December 10, 2021

Version 3

Hood Flutter or Vibration at Highway Speeds

Supersedes 17-083, dated September 18, 2018, to revise the information highlighted in **yellow**.

Updated Image:

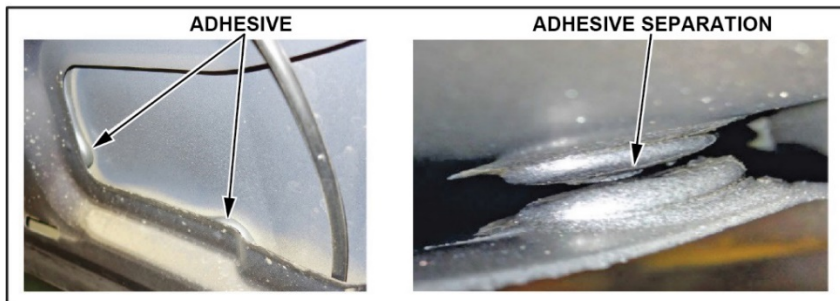
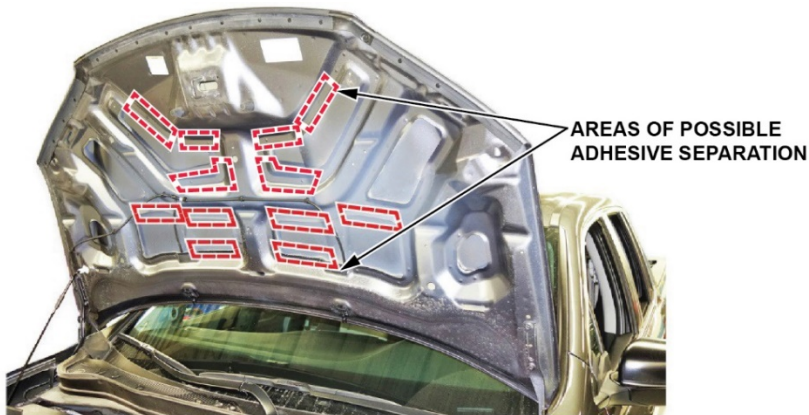
- Under AFFECTED VEHICLES, the year range was updated for Pilot, Ridgeline and Passport was added.
- Under WARRANTY CLAIM INFORMATION, the Flat Rate Time for Operation Number A was updated.
- Under REPAIR PROCEDURE, a note was added before Step 1, Step 3 image was updated, and Step 4 was added.

3. Inspect the areas shown designated with red boxes for adhesive separation between the hood skin and the support.

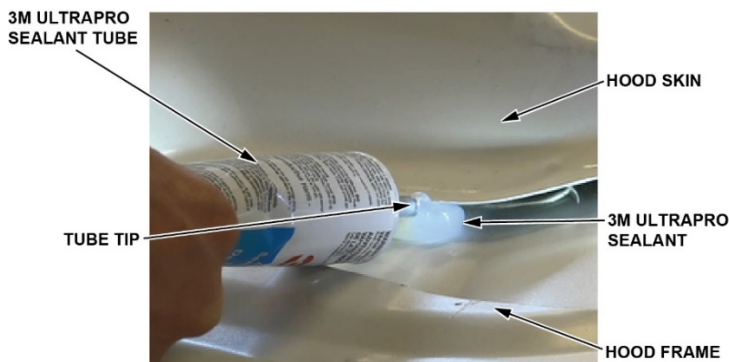
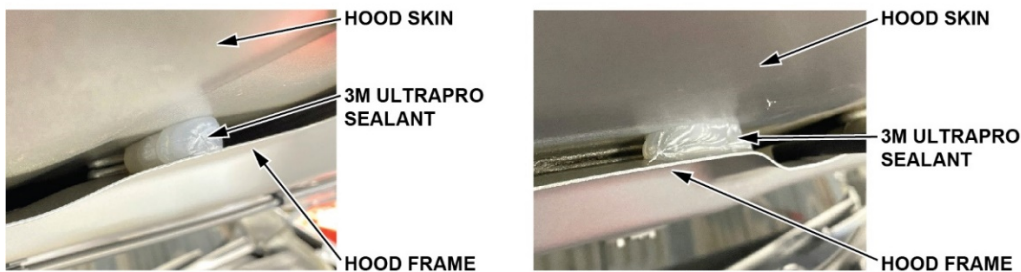
4. If separation is found, apply 3M Ultrapro sealant between the frame and the hood skin.

- Insert the tube tip between the hood skin and frame at the area of concern.
- Apply the amount of sealant needed just to where the sealant comes out to the edge of the frame.
- Ensure that there is a consistent amount of sealant touching both the hood skin and frame.
